SECTION 009113 – ADDENDUM FOUR

- A. Project Name: 22062 Picayune Multipurpose and Band Hall Renovation
- B. Owner: Picayune School District, 706 Goodyear Blvd., Picayune, MS 39466
- C. Architect: Dale | Bailey, an Association, 188 E. Capitol Street, Suite 250, Jackson, Mississippi, 39201
- D. Architect Project Number: 22062
- E. Date of Addendum Four: 13 July 2023

Picayune High School Multipurpose and Band Hall Renovation 22062 Picayune Multipurpose and Band Hall Renovation Picayune, MS

1 New Multipurpose Foundation Plan
1/8" = 1'-0"

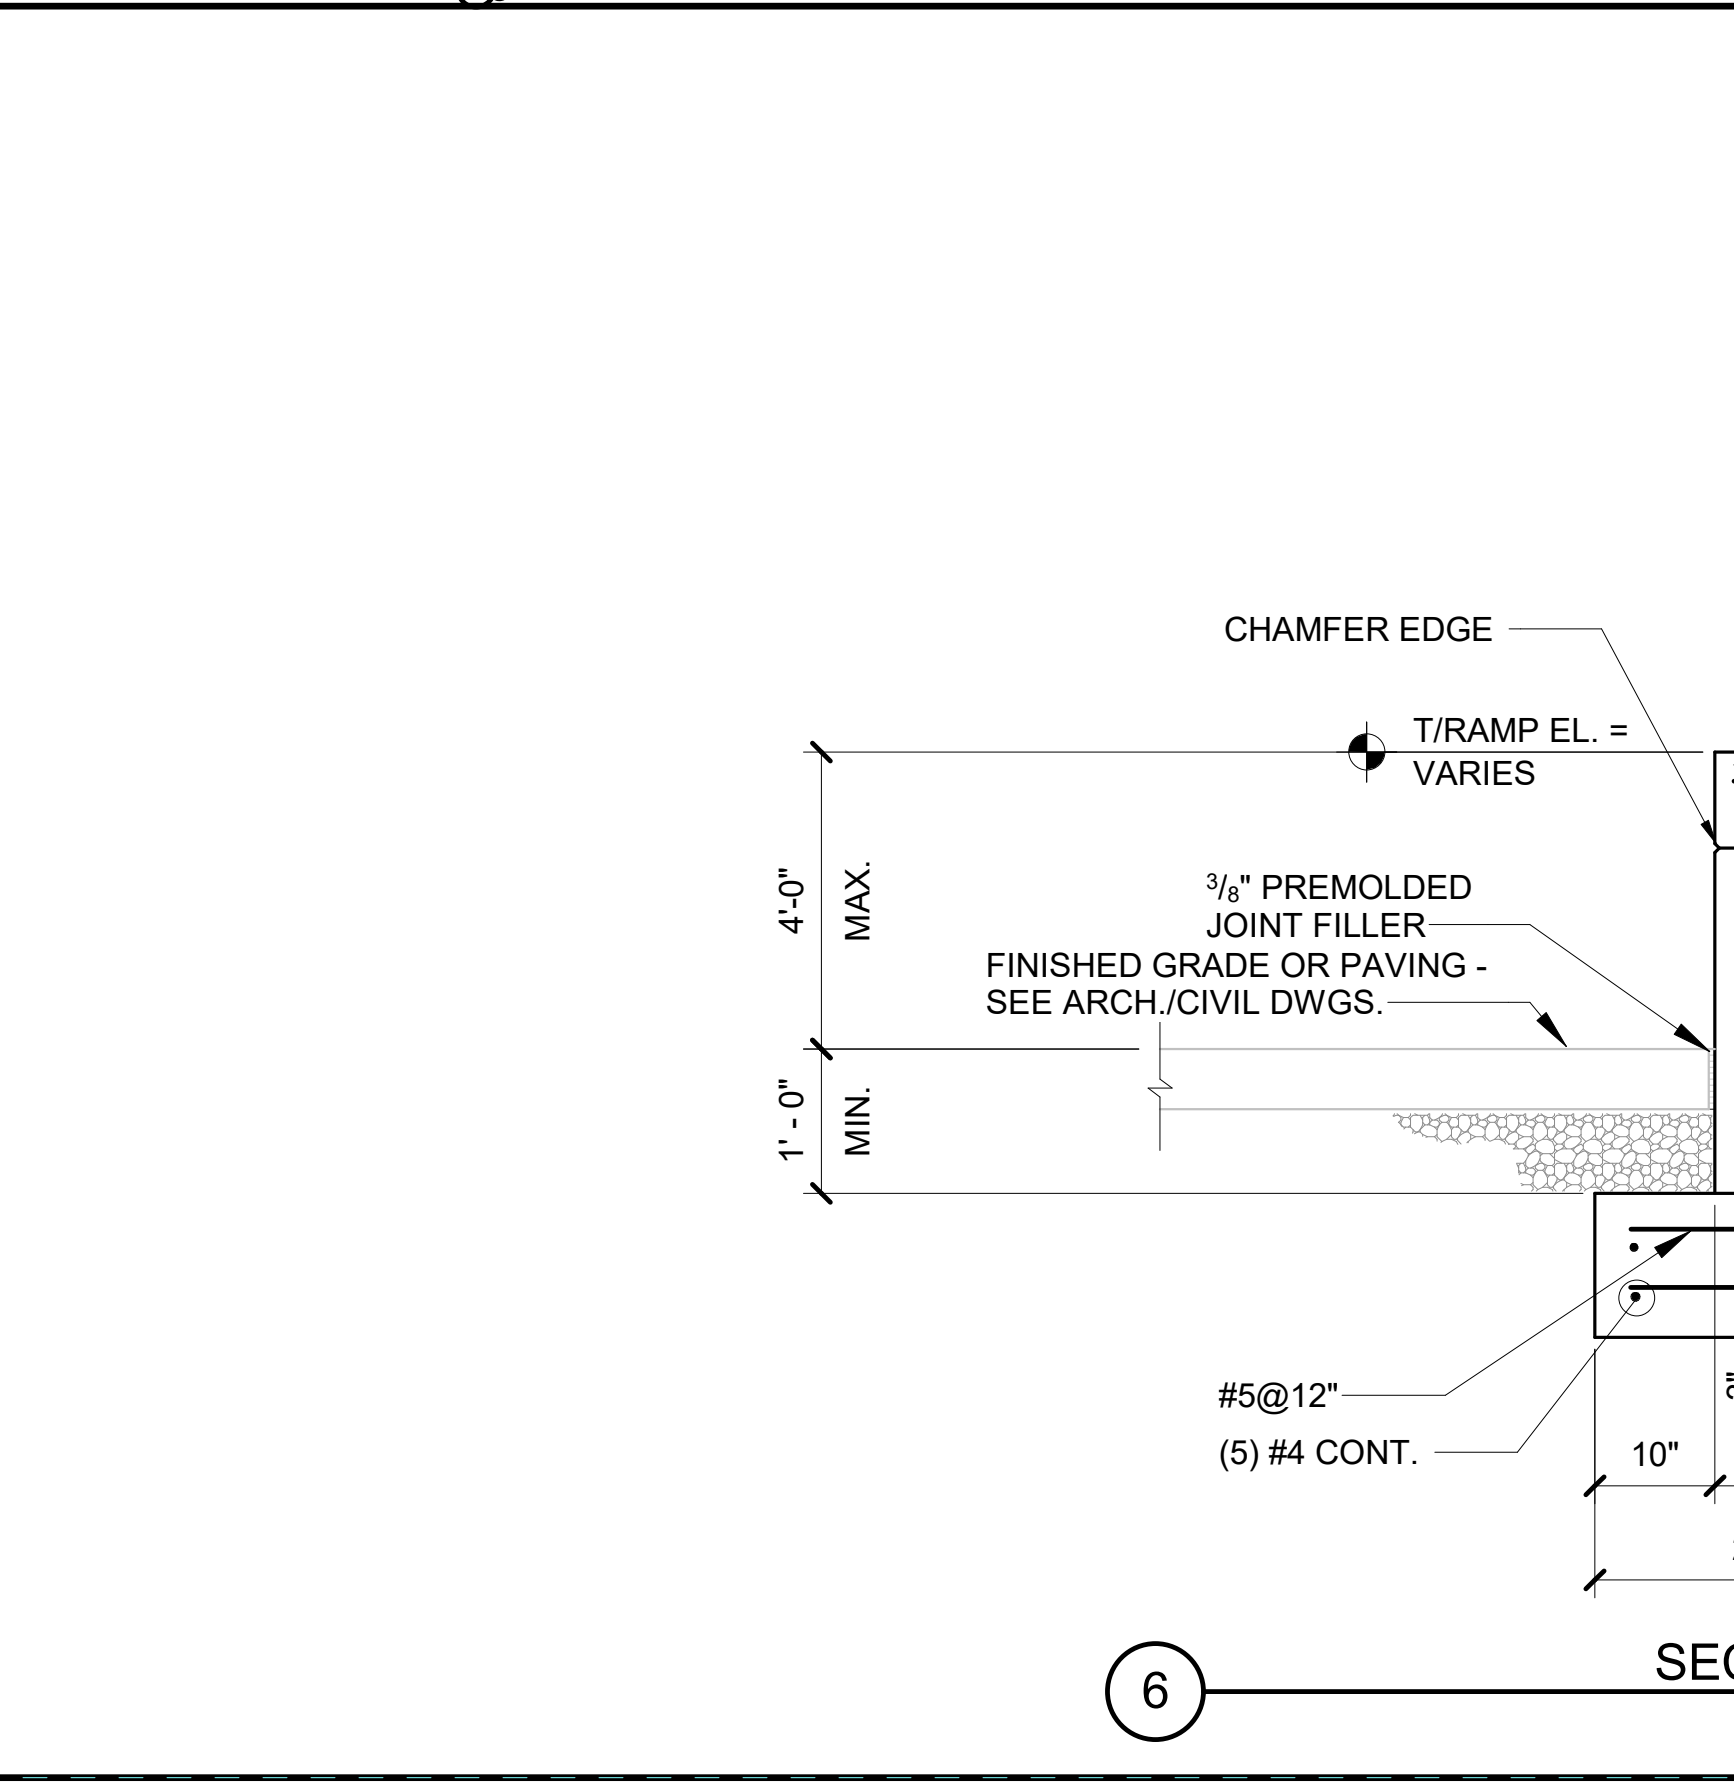
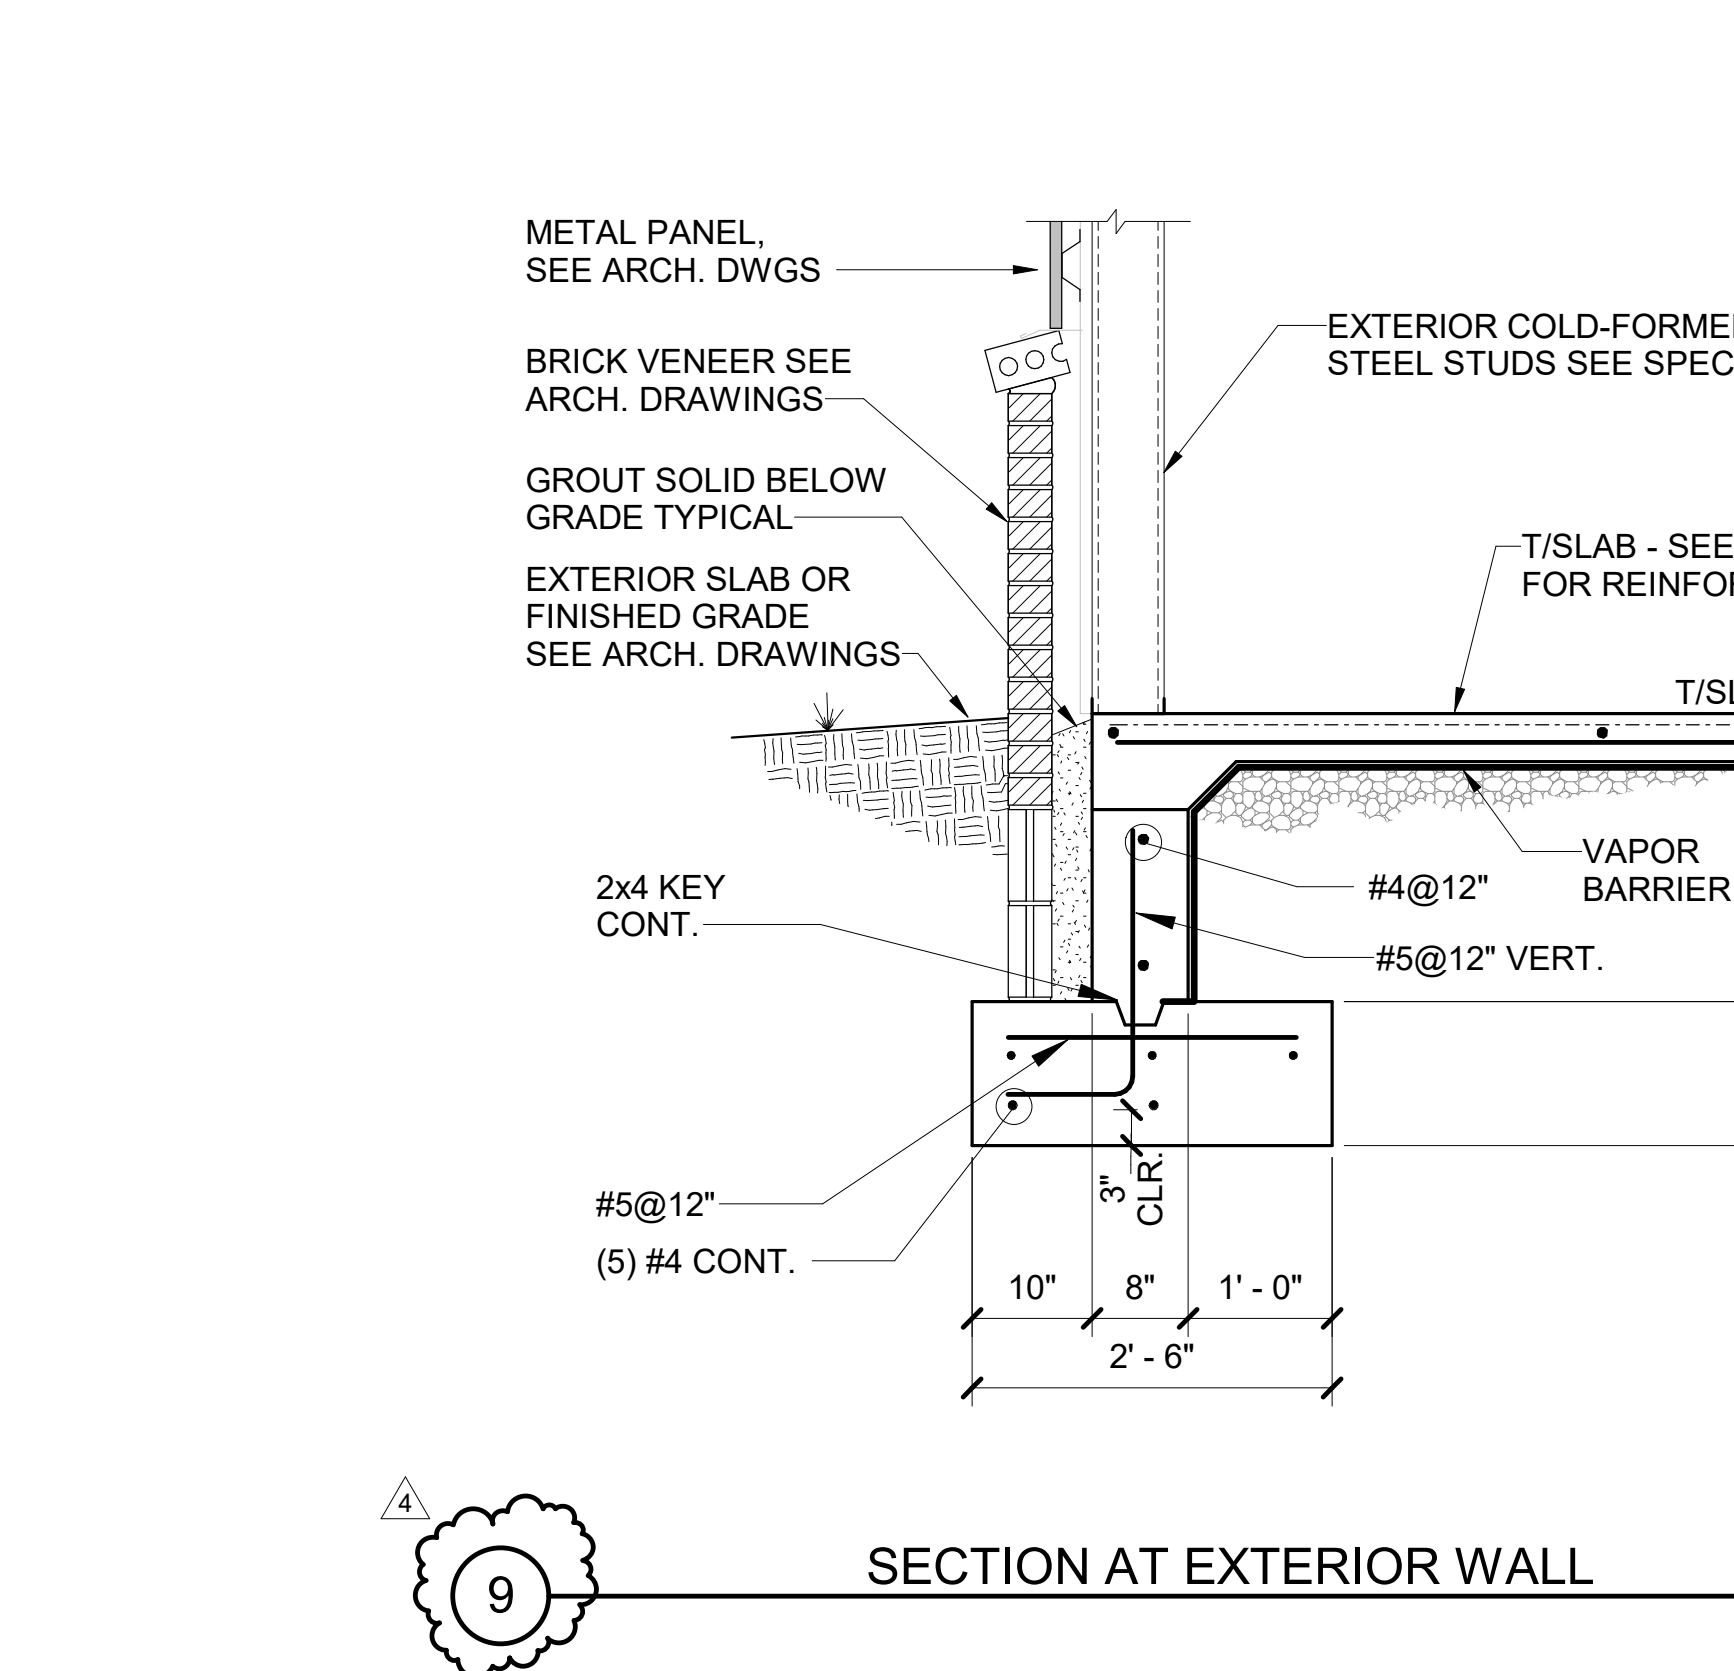
- A. Sheet S-003 – Structural Quality Assurance Plan (Not Re-Issued). Under General, 3rd paragraph: Special Inspector will be hired by the Owner.
- B. Sheet S-101 – Foundation Plans (Re-Issued). Delete this sheet in its entirety and replace it with the attached. Added foundation wall and footing to east side of building along with new sections (7/S-203, 8/s-203, 9/S-203 and 10/s-203) detailing wall and footing.
- C. Sheet S-203 – Foundations Sections and Details (Re-Issued). Delete this sheet in its entirety and replace it with the attached. Added details 7/S-203, 8/s-203, 9/S-203 and 10/s-203.
